TEST INSTRUCTIONS OP/DFG AMP  
CIRCUIT BOARD 117D9929 G-1  
FIRST MADE FOR

P3K-AL-0220

Test Instructions OP/DFG AMP  
Circuit Board 117D9929 G-1, G-2

FIGURE 1

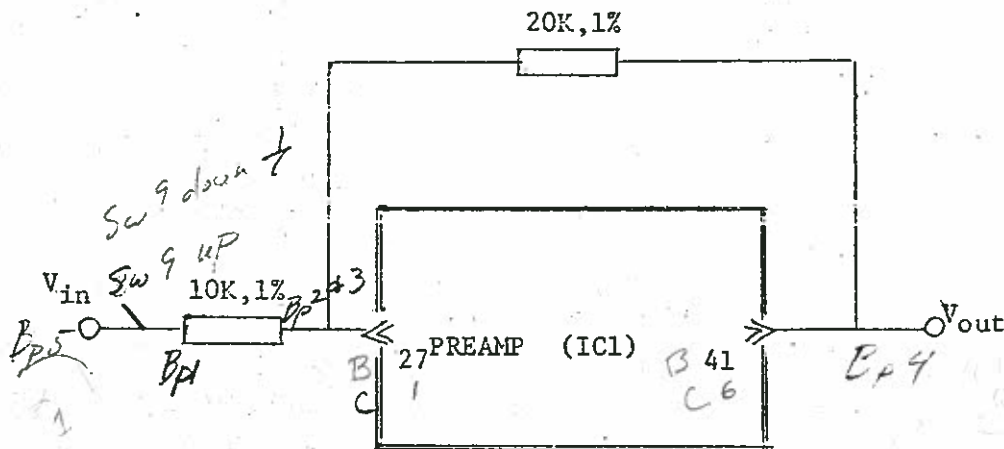
*GAIN = 2 with 3V or less input*

*clamp before 9.2V*

*GAIN OF 3 ± .05*

$$2 \text{ V} = 6 \text{ V out}$$

*FIG 1A*

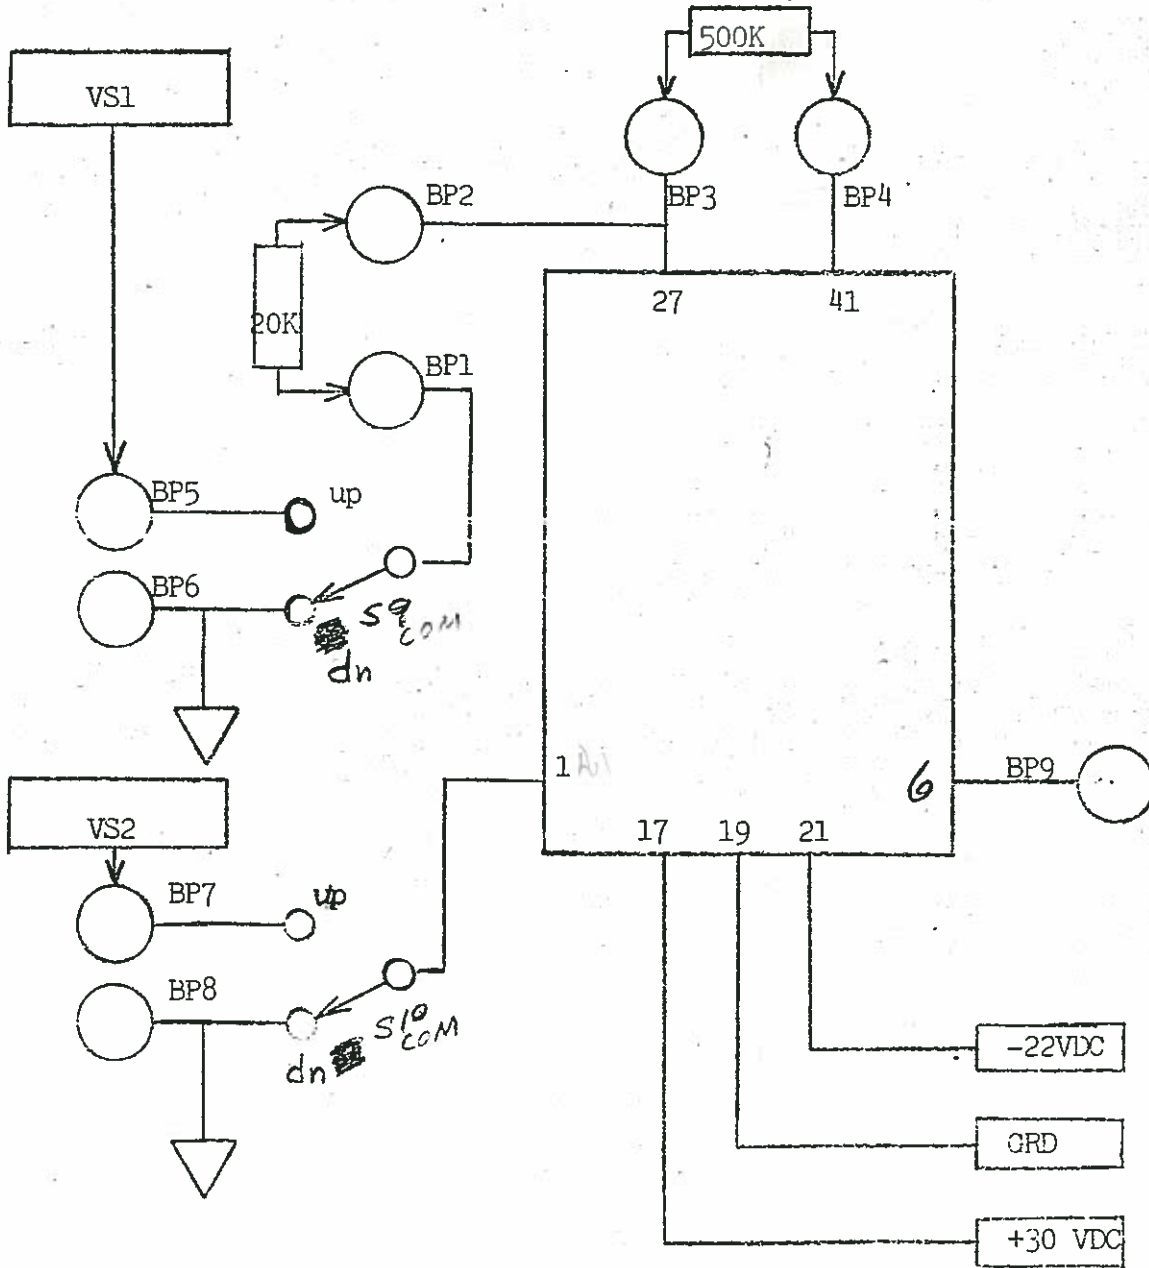
1. Connect test circuit as shown in Fig. A.
2. Check test supply voltage (Tol.  $\pm 1$  MV)
3. ~~S3~~ down S9 common (PIN 27)  
S4 down S10 pin 1 common
4. Check ckt. card supply voltages at TP1 and TP2 for +15.7 VDC and -15.7 VDC (Tol.  $\pm 1.0$  V)

5. Adj. VR1 for 0 VDC at TP4.
6. ~~S3~~ up S9 to VS1 (PIN 27)
7. Adj. VS1 for -0.100 VDC at BP1. BP5 AT PS 1
8. Check TP4 for +2.50 VDC (Tol.  $\pm 100$  MV)
9. Adj. VS1 for -1.000 VDC
10. Check TP4 volts for ~~+2.500~~ <sup>2.2 to 2.9</sup> to +9.500 VDC
11. Adj. VS1 for +1.000 VDC.
12. Check TP4 volts for ~~-7.900~~ <sup>-7.79 to -8.61</sup> to -9.500 VDC. Per E.A.

13. Adj. VR2 for 0 VDC at TP6.
14. ~~S4~~ up S10
15. Adj. VS2 for +5.00 VDC at TP5. BP7
16. Adj. VR3 for +5.00 VDC at TP6.

17. ~~S3~~ down S9 common 27 TO COM  
S4 down S10 pin 1 to common
18. Make a final trim with VR1 for 0 VDC at TP4.
19. Make a final trim with VR2 for 0 VDC at TP6.
20. Apply red locking solution to VR1 and VR2. RTV
21. End of Test.

*Patch Bnd 8-1  
1/16/84 PGB*
